SERVICE TECHNICAL INFORMATION

ONE POINT REPAIR

REF. NO. : SI-95-055

MODEL : CA-DW700M / DW710M / NSX-E7M
SUBJECT : Measures to prevent locking of the CD mechanism
SYMPTOM : The mechanism becomes locked due to slippage of the 7-CD changer gear position. To prevent the mechanism from locking, perform the remedy described below.

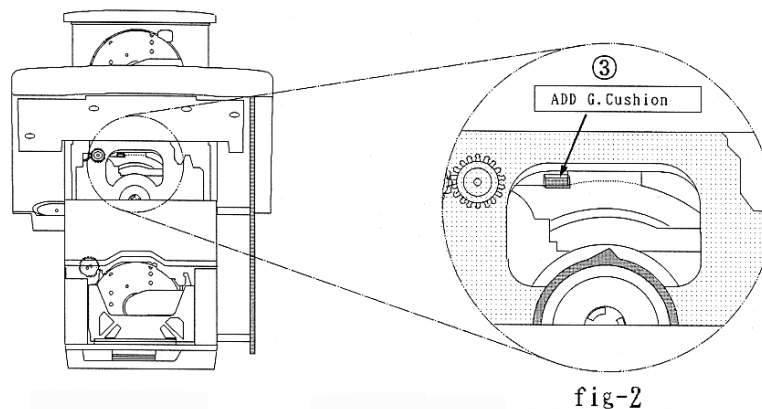
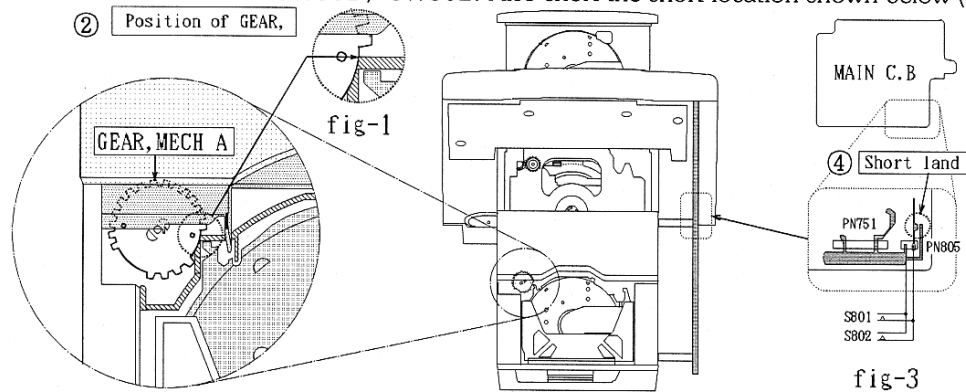
- ① Remove the rear cabinet.
- ② Check the position of GEAR, MECH A (chucking condition).
If there is slippage, adjust the position as shown below (fig-1).
- ③ Open TRAY L. Add a G • cushion to the position shown below (fig-2).
(with TRAY, DISC not in the chucking position)

Note: When performing this remedy with the rear cabinet removed, short the inclination detection switch SW801 / SW802. Also short the short location shown below (fig-3).
